August 25, 1994
G-1151-RSO-94-365

Attachment(s): GTICES Program Report Forms Nos. 94.12 and 94.13

GTISL Program Report Form

GPRF No.: 94.12

Figure 3.2 Illustration of Dynamics Verification Problem #2

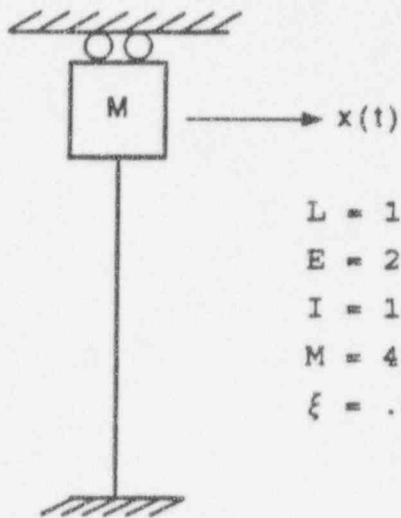
Typographical errors were found in section 3.2 "Dynamic Verification Problem #2" and section 4.3 "Nonlinear Verification Problem #2" of the GTSTRUDL Verification Manual. The corrections are shown on the attached pages.

The equation in section 3.2 was stated incorrectly, and some of the constants on the illustration pages were incorrectly stated.

Please see the attached pages for corrections and replace them with the appropriate pages in the GTSTRUDL Verification Manual.

Figure 4.3 Nonlinear Verification Problem #3 -- Nonlinear Spring Element

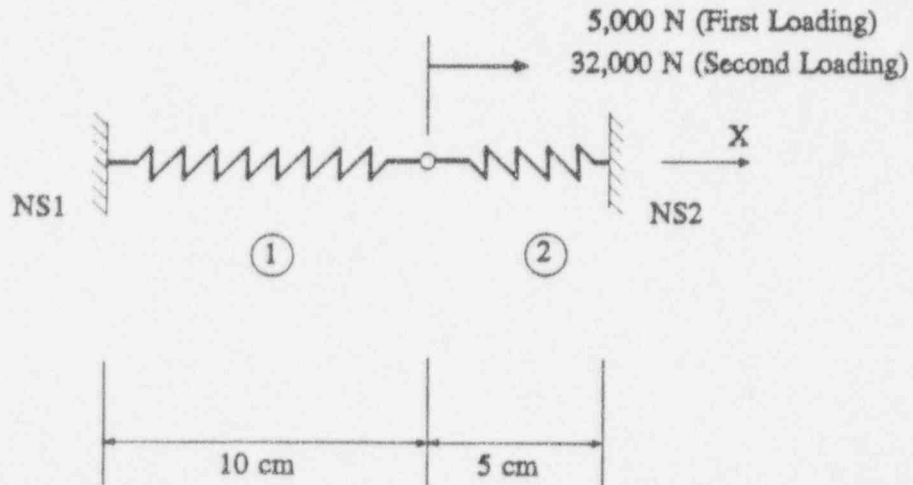
The dimensions for the figure in section 4.3, and some of the constants were incorrectly stated.
